Service Bulletin

Bulletin Number: **SB-18-299 Revision B**
 Release Date: **September 28, 2018**
 Subject: **Inspection and Potential Replacement of Hydraulic Oil Tank Mounting Brackets**
 Distribution: **Affected Heil Dealers, Customer Service, Field Service**

Figure 1. Hydraulic Oil Tank Mounting Bracket Locations (Each Side of the Hydraulic Oil Tank)

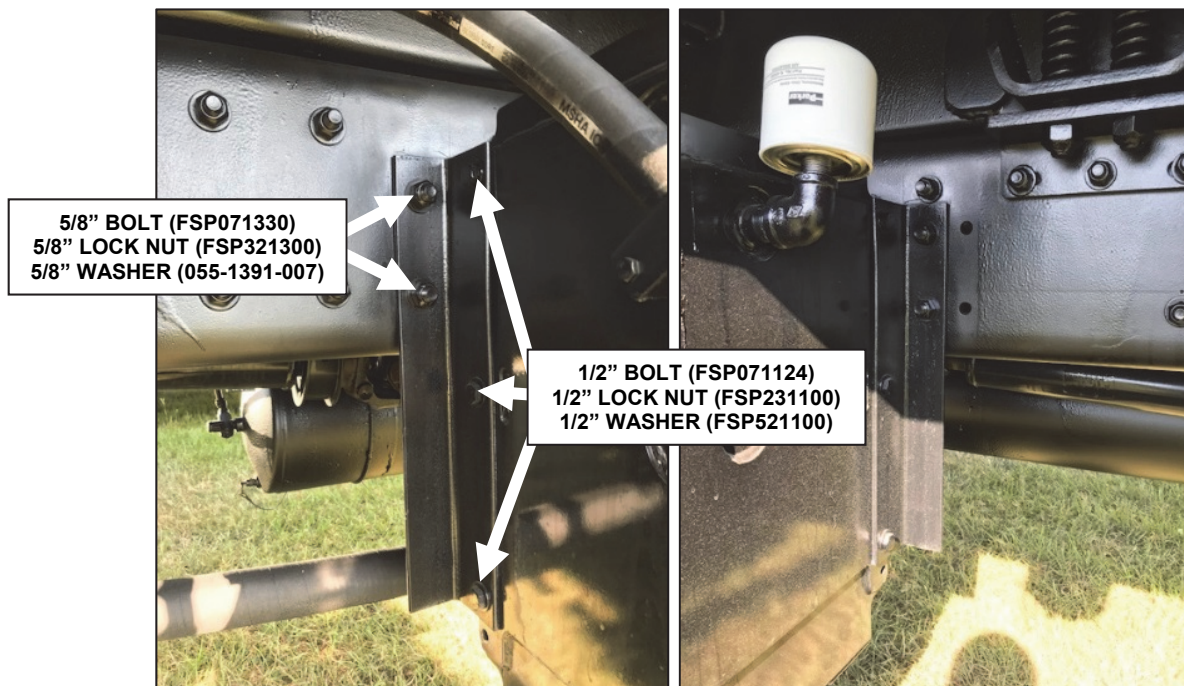
- (1) Inspect both hydraulic oil tank brackets for cracks. **NOTE:** The brackets will require periodic cleaning to ensure the inspector's visibility of any cracking is clear.
- (2) If any cracks are found, continue to Section 3.B. **NOTE:** If any bracket cracks are found, ALWAYS replace BOTH brackets.
- (3) If no cracks are found, no corrective action is required at this time.
- (4) **Hydraulic Oil Tank Mounting Bracket inspections should be added to the operator's pre- and post- trip inspection procedures.** Additionally, bracket inspections should be added to the regular Preventive Maintenance schedule to be inspected daily (every 8 hours of operation). **Replace BOTH brackets immediately if ANY cracks are found.**
